PETITION FOR VARIANCE APPLICATION

**City of Madison
Building Inspection
Division**

Name of Owner <u>Bradley Mullins</u>	Project Description <u>Renovation & Addition of existing hotel</u>	Agent, architect, or engineering firm <u>Destree Design Architects</u>
Company (if applies) <u>Park Hotel, Inc.</u>		No. & Street <u>222 W Washington Ave #310</u>
No. & Street <u>401 S. Carroll St.</u>	Tenant name (if any) <u>Inn on the Park (aka Park Hotel)</u>	City, State, Zip Code <u>Madison WI 53703</u>
City, State, Zip Code <u>Madison, WI 53703</u>	Building Address <u>22 S. Carroll St.</u>	Phone <u>608-268-1499</u>
Phone <u>608-285-8090</u>	Madison, WI	Name of Contact Person <u>Melissa Destree</u>
e-mail <u>brad@mullinsgroup.com</u>		e-mail <u>melissa@destreearchitects.com</u>

- The rule being petitioned reads as follows: (Cite the specific rule number and language. Also, indicate the nonconforming conditions for your project.)
2009 IBC 1009.5 Stairway landings are required at a door. We are requesting consideration to not have landings due to an existing condition.
- The rule being petitioned cannot be entirely satisfied because:
The hotel is requesting a safe solution to secure the existi

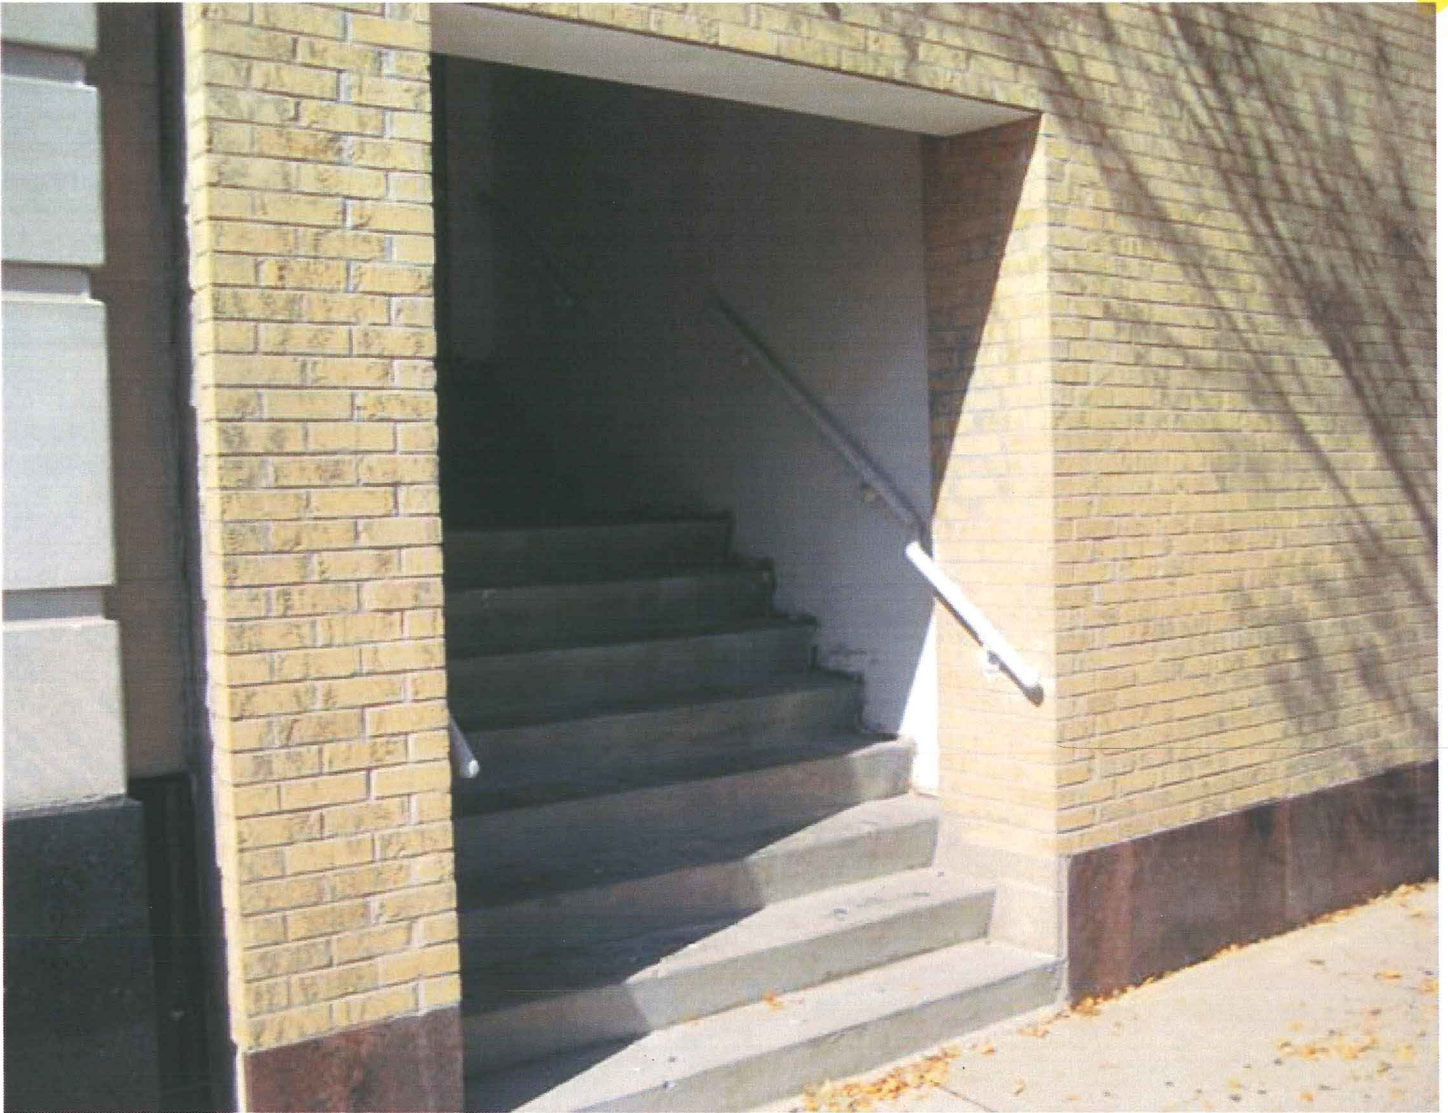
Melissa,
Central District strongly supports this proposal as a much needed solution for a long term problem. Please advise if I can be of further assistance.

Park Hotel is interested in applying for a Building Variance to add a mesh gate on the first step of our exit stairs on Main Street (photo below of existing condition). Individuals sleep in the stair, urinate, loiter, etc. With your support of the variance, we are able to eliminate this vagrancy and create a safer place. The attached PDF shows the design of the proposed gate doors. They are decorative mesh, so you can see in the stair, however the public is not able to reach in to open the gate from the exterior.

The Building Variance is require due to a lack of a 5 foot landing at the gate location. We have been working with MFD and City inspection. We are getting strong support for the variance request. Bill Sullivan of MFD, Mike VanErem with Inspection, etc. are happy to support the request if our alder, on-site building inspector, police, etc also see benefit in the request. So I'm reaching out to you for your support to secure this exposed stair area.

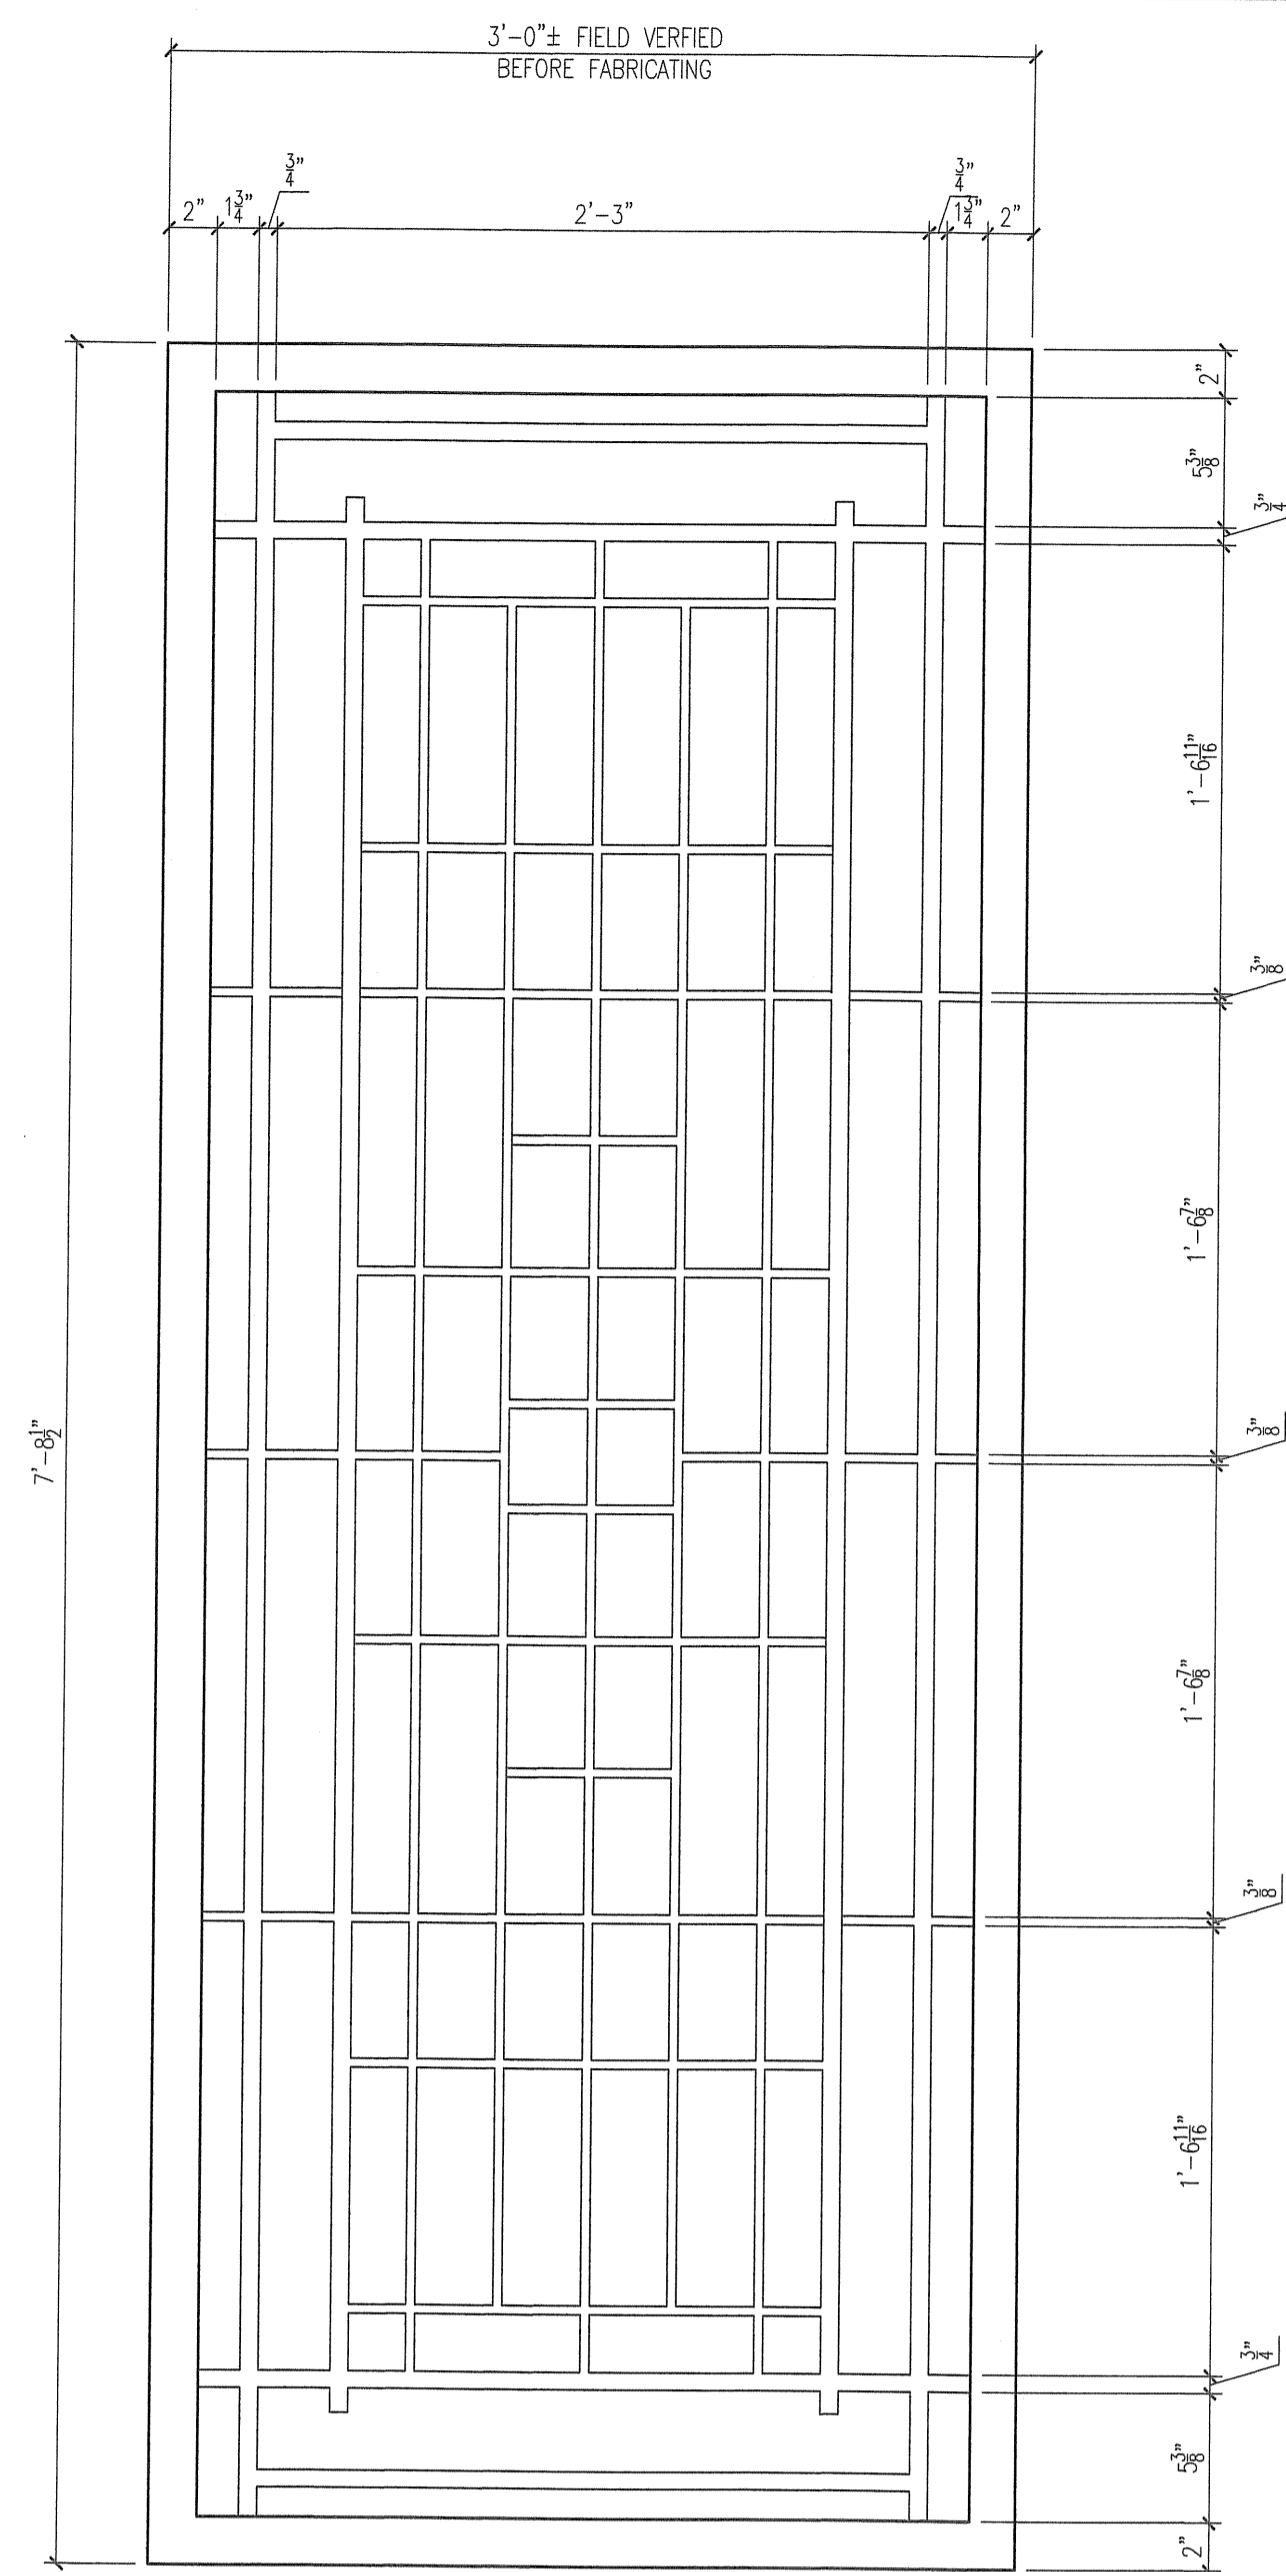
So with your support, Park Hotel is interested in applying for a Building Variance to add a mesh gate on the first step of our exit stairs on Main Street (photo below of existing condition). The attached PDF shows the design of the proposed gate doors. They gate doors are decorative mesh, so you can see in the stair, however the public is not able to reach in to open the gate from the exterior. The egress bar will be mounted higher to address the lack of a landing.

Yes it makes sense to me. It would support it.
